Sorted by Roberto43 10-08-2003

Television MG3.1E, MG3.1A, MG3.1U, MG3.2E Chassis: MG3.1E, MG3.1A, MG3.1U, MG3.2E

Reference Number: HE-03/0017

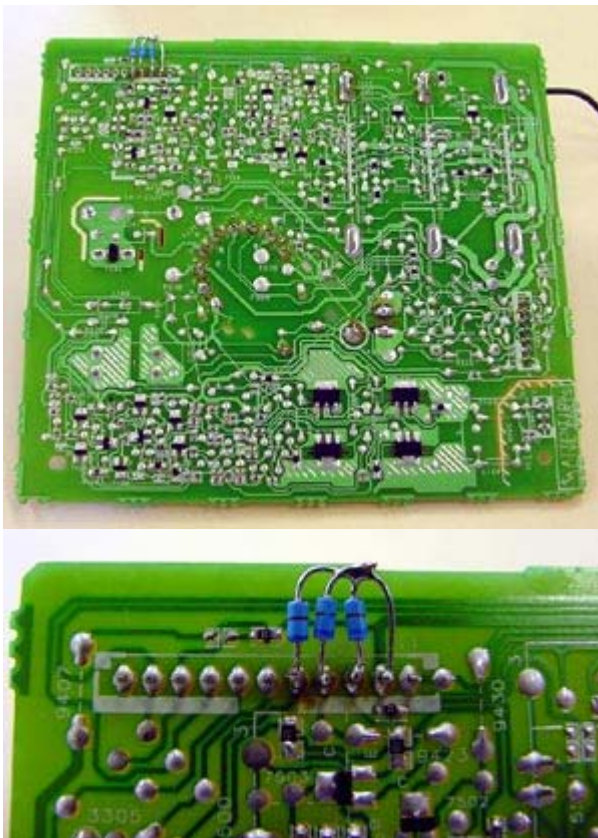
Symptom: Several symptoms are possible:

- 1) One or more colours missing in the picture, or
- 2) Switch-off spot, or

3) Long start-up time (about 30 seconds).

Cure: Check transistors 7500, 7503, and 7506 (BFS20, 5322 130 42718) on the CRT-panel and replace when defective. As a future flash protection, add three diodes (BAW62, 9331 012 20133) to pins 7, 8, and 9 of connector 1940. Connect the three diode anodes together to the ground signal pin 10 of connector 1940.

Remarks: 1) Due to a picture tube flash, transistors 7500, 7503, and 7506 on the CRT-panel can become defective.

Fig. 1.1

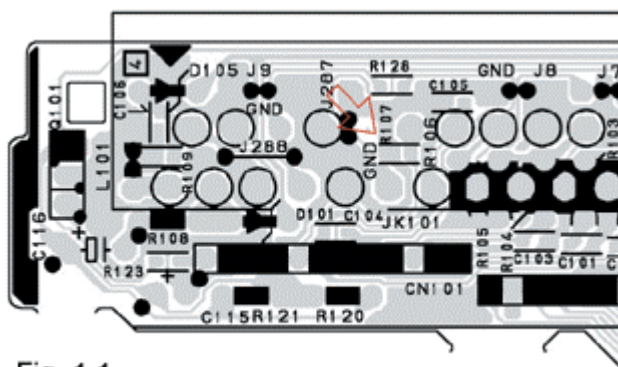
Symptom: In case a TV set which supports P50 (NextView Link/Cinema Link) is connected via Scart 2 to one of the above mentioned VCR's it may happen that the TV set is blocked and does not switch on from STANDBY.

Cure: Pin 10 of Scart 1 in the VCR sets is connected to ground. Please remove resistor R107 on the Jack Board (next to pin 10 of Scart 1 – see fig. 1-1).
